Title: Advisory Committee on Reactor Safeguards
 Subcommittee on ESBWR: Open Session

Date: Monday, August 16, 2010

Chapter 15, Safety Analyses

LTR NEDO-33373, "Dynamic, Load-Drop and Thermal-Hydraulic Analysis for ESBWR Fuel Racks"

Streamlines from Inlet to Outlet (Abnormal Condition)

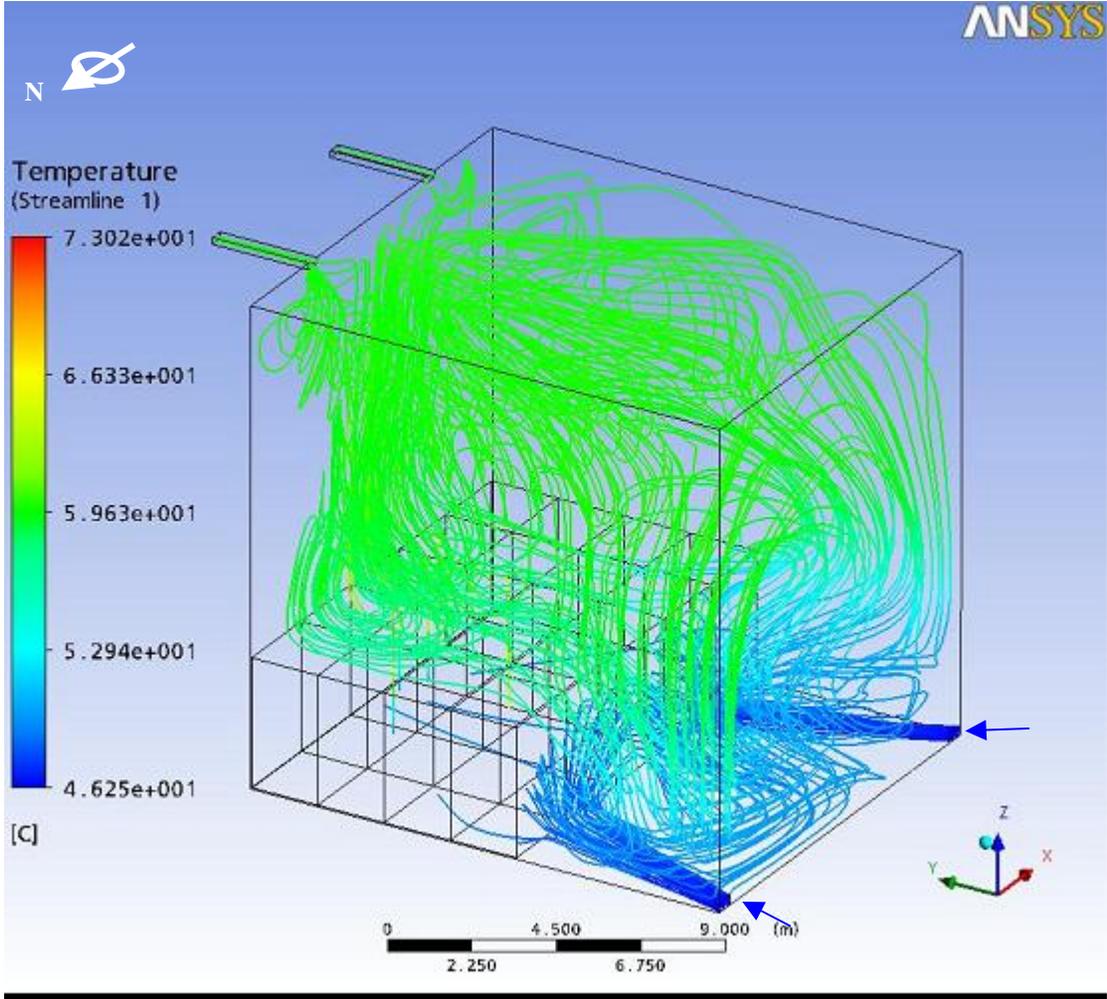
19 CONSULTANT WALLIS: And nothing seems to
20 go through the rack at all, and the green things are
21 doing very peculiar things. Presumably -- I have
22 great faith in Chris Boyd, but someone -- There must
23 be a better figure than this to show what is
24 happening. Did your review find more realistic
25 figures that actually showed something -- that the

1 fuel was being cooled? This doesn't show anything
2 cooling the fuel at all.

1 CONSULTANT WALLIS: I was just surprised
2 that this figure was presented as showing -- to sort
3 of convince us that CFX is working properly.

13 CONSULTANT WALLIS: This is supposed to
14 show that the racks are cool, and there is nothing
15 going through the racks at all. So this is a very
16 strange figure to present to show that the racks are
17 cool. There must be better figures somewhere.

7 CONSULTANT WALLIS: But then you should go
8 back and say let's see a figure which does demonstrate
9 that the reactor is cool. I am kind of puzzled by the
10 presentation of this very mysterious figure.

11 CONSULTANT WALLIS: Yes. I agree with
12 Tom. I have real problems with this spent fuel
13 cooling. I mean, there is a figure that we got handed
14 out here. It shows the two stream lines coming in and
15 two going out, and they wander around for about 100
16 seconds before they go out, and this doesn't really
17 convince me that they cool the fuel. They don't even
18 seem to go through the fuel. There is something very
19 strange about this. It may well be that --

3 MR. GILMER: We don't have a better
4 figure, but we did look at the --

18 MR. GILMER: Well, there is another figure
19 in the GEH presentation that --
